Access Compliance Report

Public Rights-of-Way

(Curb Ramps)

Intersection ID: 13071	Main Street: N_SHARON_AMITY_RD	Cross Street: VERNEDALE_RD	Location: E
ADA ID: 37FA82C4F550	Ramp Type: Perp	Initial Pass/Fail: Fail	Overall Compliance: No
Severity Score: 21.25			
Codes/Mitigation Info/Possible Solution		Field Measurements/Component Compliance

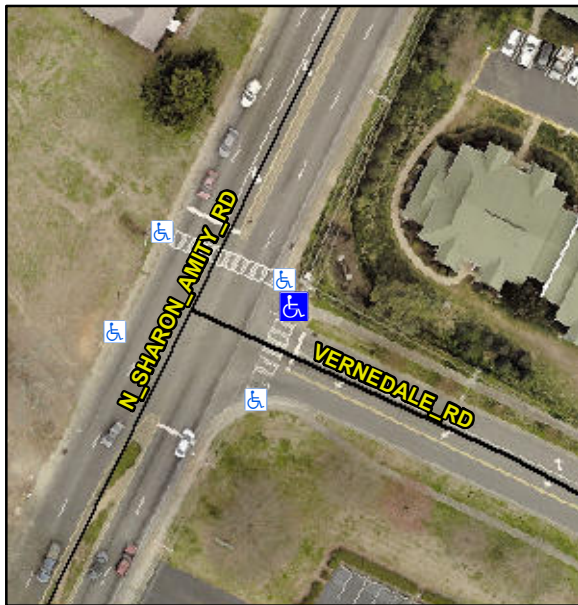
Not Found, R304.5.1, R304.2.2

Compliance	Description	Data	Compliance	Description	Data
N/A	Ramp Length (in)	65.0	No	Ramp Slope (%)	8.4
No	Ramp Width (in)	39.0	Yes	Ramp XSlope (%)	1.9
N/A	Flare Type LT	N/A	N/A	Flare Type RT	N/A
N/A	Flare Slope LT (%)	N/A	N/A	Flare Slope RT (%)	N/A
N/A	Flare Traversable LT?	N/A	N/A	Flare Traversable RT?	N/A
N/A	Landing Length (in)	N/A	N/A	DWS Provided?	N/A
N/A	Landing Width (in)	N/A	N/A	DWS Contrast?	N/A
N/A	Landing Slope (%)	N/A	N/A	DWS Length (in)	N/A
N/A	Landing X Slope (%)	N/A	N/A	DWS Full Width?	N/A
N/A	Landing Curb? (Y/N)	N/A	N/A	DWS Offset (in)	N/A
N/A	Shared Landing?	N/A			
N/A	Gutter Ponding?	N/A	N/A	Gutter Slope (%)	N/A
N/A	Gutter Lip Ht (in)	N/A	N/A	Gutter X Slope (%)	N/A
N/A	Painted X Walk1?	Yes	N/A	Painted X Walk2?	N/A
	X Walk 1 Direction	To SW		X Walk 2 Direction	N/A
N/A	X Walk 1 Width (in)	112.0	N/A	X Walk 2 Width (in)	N/A
	X Walk 1 Slope (%)	1.9		X Walk 2 Slope (%)	N/A
	X Walk 1 X Slope (%)	2.7		X Walk 2 X Slope (%)	N/A

N/A	Ramp inside XWalk1?	Yes	N/A	Ramp inside XWalk2?	N/A
	Road Slope (%)	N/A	N/A	Clear Space?	N/A
	Road X Slope (%)	N/A	N/A	Clear Space to XWalk (in)	N/A
N/A	Any Obstructions?	N/A	N/A	Storm Grate/Utility Hazard?	N/A
	Obstruction Type			Storm Grate/Utility Type	
		N/A			N/A
			Yes	Surface Condition? (G/P)	Good

Remove & Replace Entire Ramp.
